Remarks

The Application has been carefully reviewed in light of the final Office Action mailed June 18, 2003. Although Applicants believe all original claims are allowable without amendment, to expedite issuance of a patent from the Application, Applicants make clarifying amendments to Claims 1, 8, and 15. None of these changes is considered necessary for patentability. These amendments do not raise new issues and will not require further searching. These amendments will also place the Application in better condition for appeal if the Examiner maintains the Examiner's rejections. Accordingly, Applicants respectfully request that these amendments be entered. Applicants respectfully request reconsideration and allowance of all pending claims.

Applicants Propose Amendments to Drawings

FIG. 2

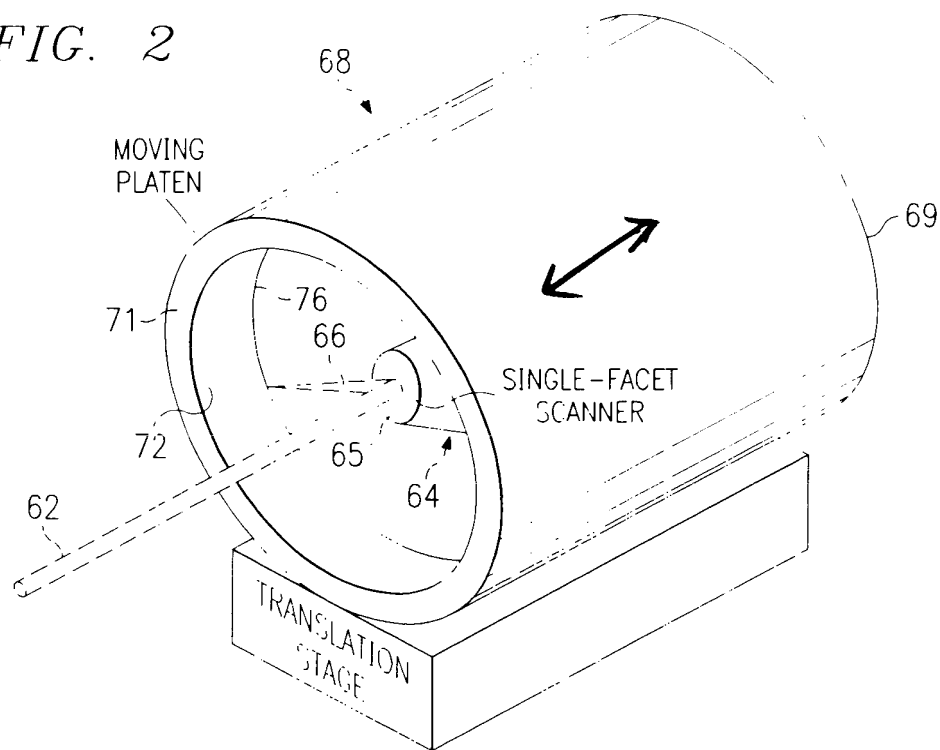
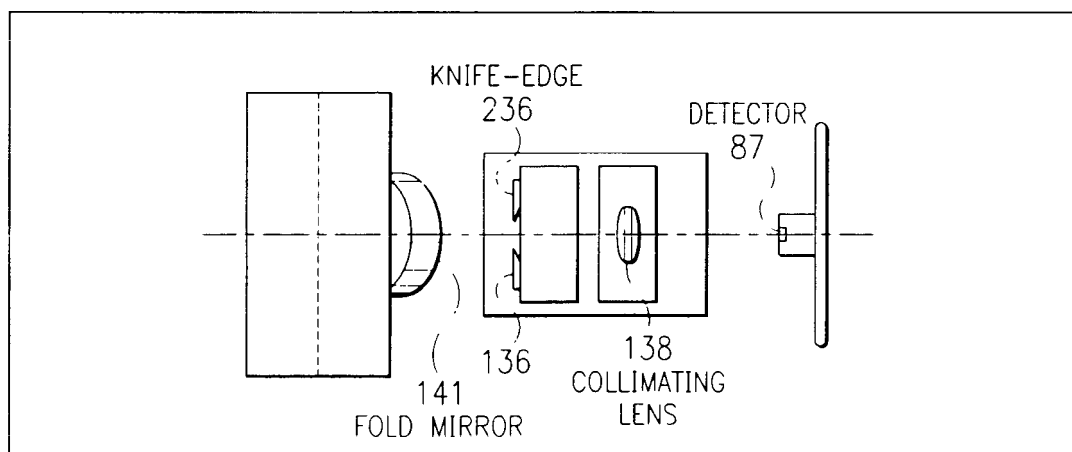
The Examiner objects to the drawings. According to the Examiner, "the relative direction of the curved writing surface's translocation and the stationary frame as being cited in Claims 1, 8 and 15 must be shown or the feature(s) canceled from the claim(s)." Applicants propose adding arrows to FIGURES 2, 2A, and 7 that show translation of a translation cylinder and a curved writing platen. A marked-up sheet showing the proposed changes to FIGURES 2, 2A, and 7 and replacement sheets are attached. A marked-up sheet showing the proposed changes to FIGURES 2, 2A, and 7 and replacement sheets are attached. A Letter to the Official Draftsperson (with attached marked-up sheets and replacements sheets) is enclosed with this Response. These proposed changes do not add new matter to the Application. Applicants respectfully request that the Examiner accept the proposed amendments to FIGURE 11 and withdraw the objection to the Specification.
